**TOWN OF NEWBURGH  
PLANNING BOARD  
TECHNICAL REVIEW COMMENTS**

**PROJECT NAME:** FAC SELF STORAGE/UHAUL-MIDDLEHOPE  
**PROJECT NO.:** 2021-33  
**PROJECT LOCATION:** SECTION 6, BLOCK 1, LOT 11 & 12  
**REVIEW DATE:** 10 DECEMBER 2021  
**MEETING DATE:** 16 DECEMBER 2021  
**PROJECT REPRESENTATIVE:** MECURIO-NORTON-TAROLLI- MARSHALL

### Sewage Disposal System Details for Site Plan for U-Haul Self-Storage

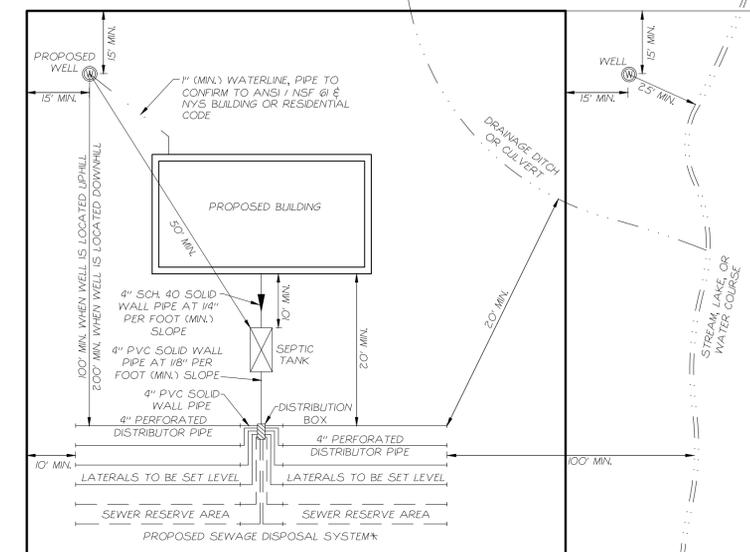
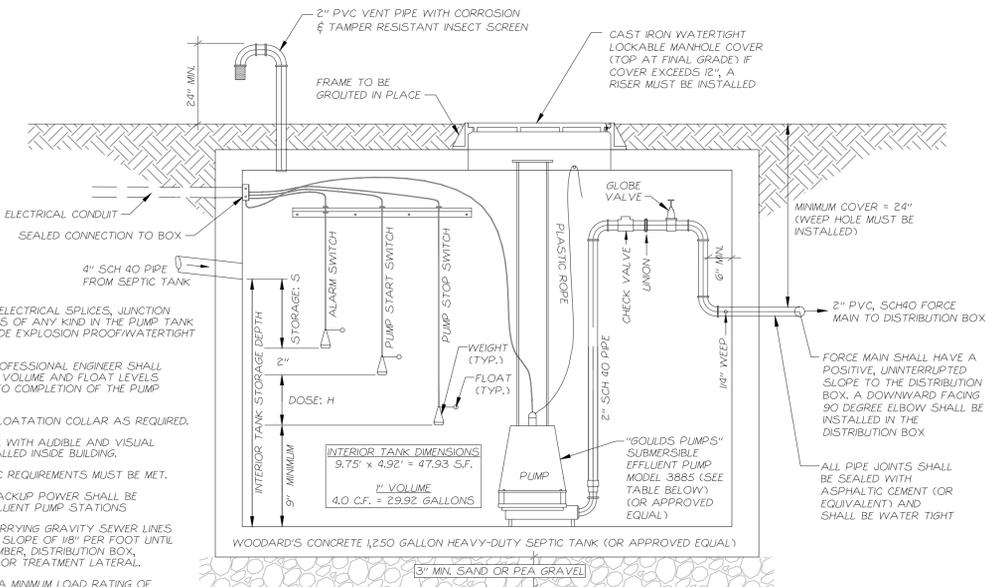
5. Soil test results for the sub surface sanitary sewer disposal system should be placed on the plans.
6. The sanitary sewer disposal system identifies a note which states the design flow rate of 150 gallons per day while the Design Chart identifies 100 gallons per day.

**Soils Testing & Water Service Details for Site Plan for U-Haul Self-Storage**

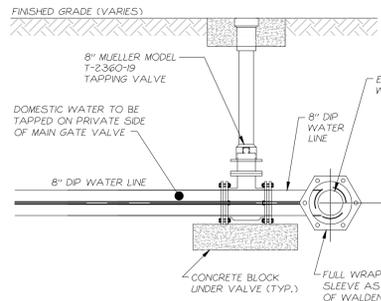
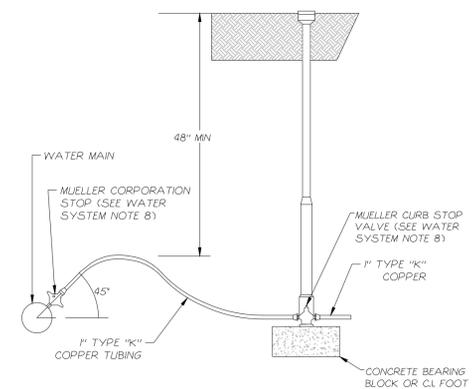
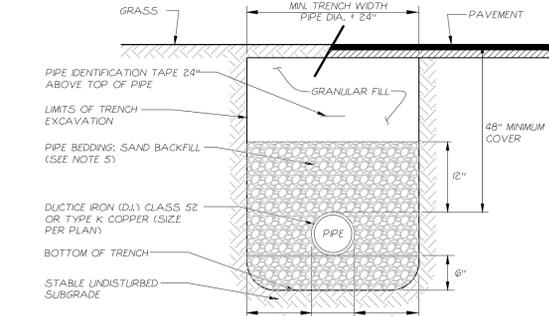
4. Valving for the water line should provide for a valve before the potable water valve such that when fire protection water is terminated potable water to the structure is similarly terminated.
